Manual Supplement

Manual Title: 8922A
Part Number: 522052
Print Date: June 1979
Revision/Date:

Supplement Issue: 7
Issue Date: 1/96
Page Count: 10

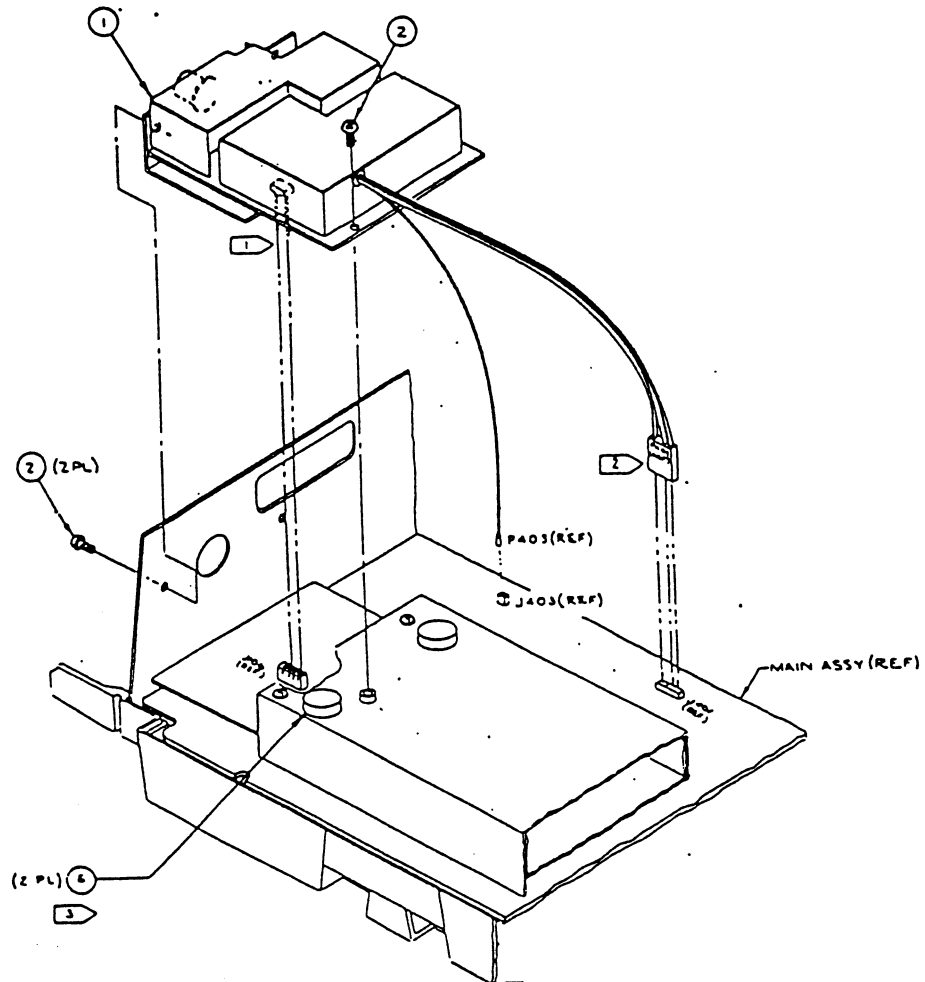
On page 603-1, paragraph 603-6, add new steps 4 and 5 as follows, and renumber old steps 4 and 5 as step 6 and 7.

4. Connect ground wire (P403) to J403 on the A1 Main PCB Assembly.
5. Place the rubber foot on the AC shield near the screws as shown in Figure 603-1.

On page 603-2, replace Figure 603-1 with:

8920A-1615
Active Load

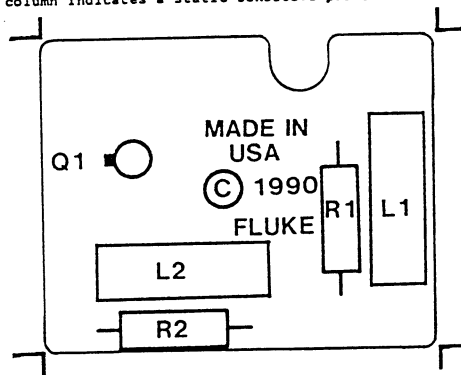
After page 5-18, add the following:

Table 5-5. A2A1 Active Load Assembly

**8920A-1015
Active Load**

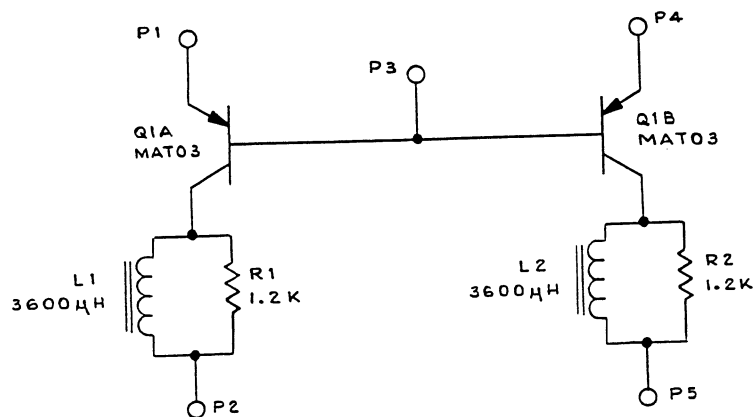
After page 8-8, Figure 8-3, add the following:

On pages 5-18, 8-6 and 8-8, Figure 5-4 and Figure 8-3, delete Q8 and Q36.
